ADDENDUM No. 1

REQUEST FOR PROPOSAL No.:	1220-030-2024-055
TITLE:	DESIGN & CONSTRUCTION ADMINISTRATION SERVICES - SOFTBALL CITY PARKING LOT
ADDENDUM ISSUE DATE:	NOVEMBER 29, 2024
CLOSING DATE AND TIME:	ON OR BEFORE THE FOLLOWING DATE AND TIME (THE "CLOSING TIME"):
	TIME: 3:00 P.M. (LOCAL TIME)
	DATE: December 5 th 2024
	NOVEMBER 29, 2024 ON OR BEFORE THE FOLLOWING DATE AND TIME (THE "CLOSING TIME"): TIME: 3:00 P.M. (LOCAL TIME)

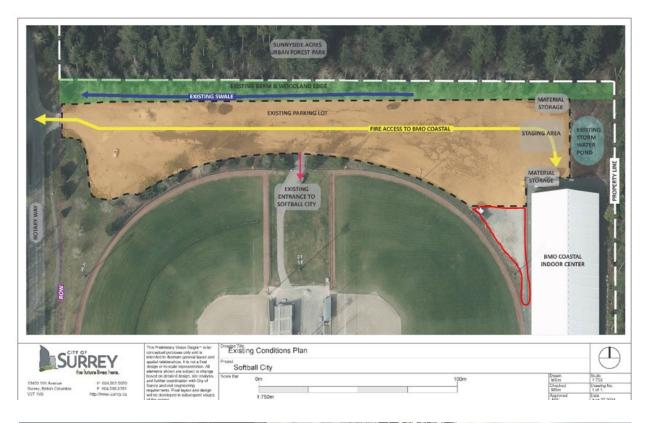
- Q9. Please confirm the topographic survey will include the triangular gravel area on Southeast corner of the proposed parking lot.
- A9. Triangular gravel area shall be included as part of topographic survey. Please follow the log edge and continue into the Southeast corner to align with the site boundary. Please see the diagram below for the Southeast site boundary in red and the picture of the Southeast log edge.
